Determination 2015/057

Regarding the refusal to issue a building consent for Stage One of remediation to an apartment complex at 716 Frankton Road, Queenstown

2.3.2 The two subject buildings are shown in Figure 2:

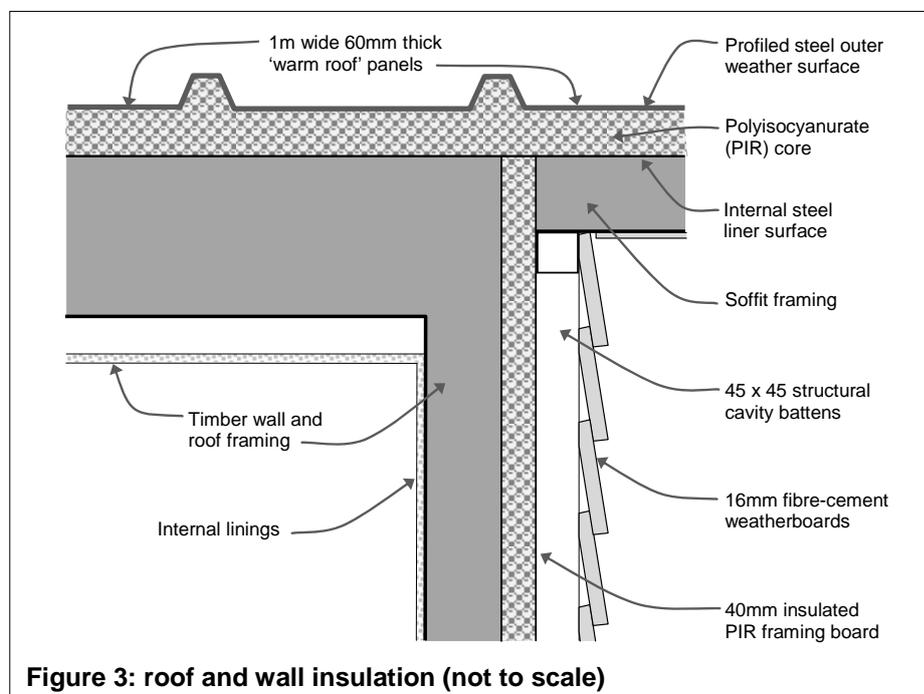
- no evidence of condensation within unventilated spaces within walls and roofs
- any potential for condensation occurred outside the structural building line.

- The steady state analysis showed condensation may form on the inner face of the external metal skin of roof panels, and this can significantly decrease overall thermal performance.

- The TAS modelling focused on the projected dew point location and the prevalence of condensation, rather than the effect of internal moisture on construction elements, building surfaces, and other items given the lack of vapour diffusion through the wall and roof insulation panels.

- The habitable spaces within the units are expected to sometimes reach more than 70%RH, which would be conducive to mould growth and/or decay regardless of condensation. This is particularly concerning during winter with high internal temperatures and occupants not wanting to open windows.

5.8.1 Based on the above, and taking into account the particular circumstances of the units, their occupancy and location; I am not satisfied that the ventilation measures proposed for the units will adequately manage the generation of internal moisture during the coldest months of the year. I am therefore not satisfied that the proposed remediation work will comply with Clause E3 of the Building Code.

5.8.2 In addition, the required durability period for the underlying wall and roof structures is a minimum of 50 years. Because the lack of automatic ventilation measures may allow condensation moisture into the framing, the building work also does not protect the framing adequately for it to comply with the durability requirements of Clause B2 insofar as it applies to Clause B1.
